ADA Curb Ramp New Construction Inspection Form (Perpendicular)

Nw Kaye way

24952.54

Nw mays st

PERPENDICULAR RAMP (PR)

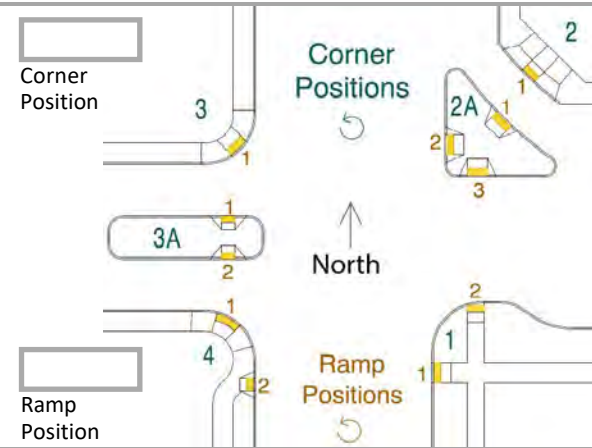
Slope X

2.6

> 2.0%

IITD rr1 icrr rr1 crack in panel
